UNITED STATES PATENT AND TRADEMARK OFFICE

APPLICATION NO.	FILING DATE	FIRST NAMED INVENTOR	ATTORNEY DOCKET NO.	CONFIRMATION NO.
10/566,284	03/02/2006	Su Gen Kim	114260017	5165
24573	7590	09/02/2009		
K&L Gates LLP P.O. Box 1135 CHICAGO, IL 60690			EXAMINER KEE, FANNIE C	
			ART UNIT 3679	PAPER NUMBER
			MAIL DATE 09/02/2009	DELIVERY MODE PAPER

Office Action Summary

DETAILED ACTION

FIG. 2

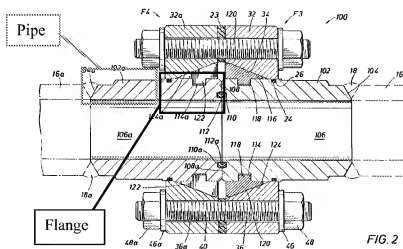
With regard to claim 1, and as seen in Figure 2 below, Baker discloses a pipe joint device, comprising:

flanges (102a, 102) mounted to ends of pipes to be coupled together or ends of both a pipe and a pipe joint to be coupled together, the flange having at least one ring groove (grooves at (114, 114a) around an outer circumferential surface thereof;

a packing (122, 120) mounted to the flanges and having inner rings protruding from and integrally formed around an inner circumferential surface of the packing to closely engage with the ring grooves of the flanges; and

a clamp (32a, 32) having a packing seat (34, 124a) to seat the packing therein, with a support sidewall formed by a radial inward extension of each side of the clamp, the clamp being divided into a plurality of clamp parts so that the clamp parts are placed around the packing and are fastened together by a locking member.

With regard to claim 6, and as seen in Figure 2, Baker discloses the flanges being stopped by the support sidewalls of the clamp (via the sealed connection between the support sidewalls and the seals 24 and 24a) so that the pipes or the pipe and the pipe joint are prevented from being removed from the clamp.
